March 2024
SF681 A-C
(Revised September 2024)

Subject: eCascadia Software Package Update

Models Affected: Specific model years 2023-2024 Freightliner eCascadia vehicles, manufactured May 16, 2022, through September 19, 2023.

REVISION: Steps 19 & 20 have been added to ensure the DCB is unlocked.

Fig. 38, DCB Lock Release Panel

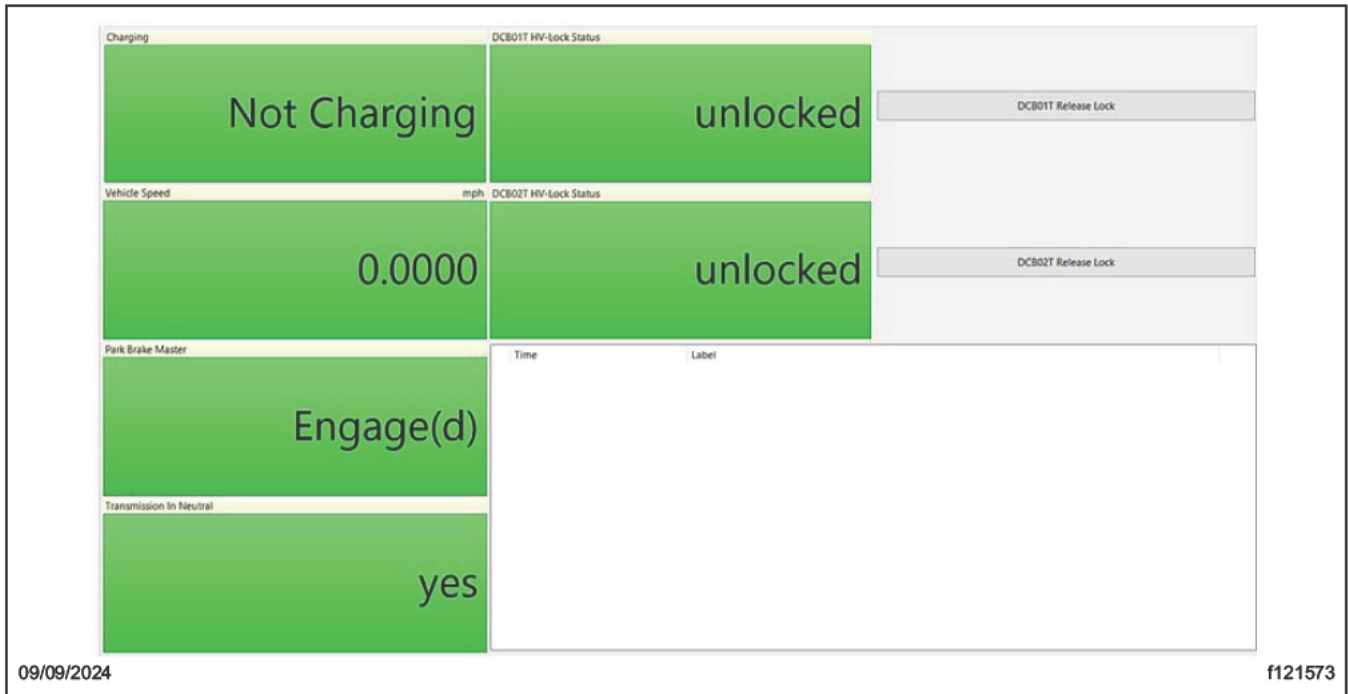
19. Go to the 'Service Routines' tab, and launch the 'DCB Lock Release' panel.
 - 19.1 If the 'DCB HV-Lock Status' does not show as 'unlocked,' select the 'DCB Release Lock' button, and allow the procedure to complete. See [Fig. 38](#).
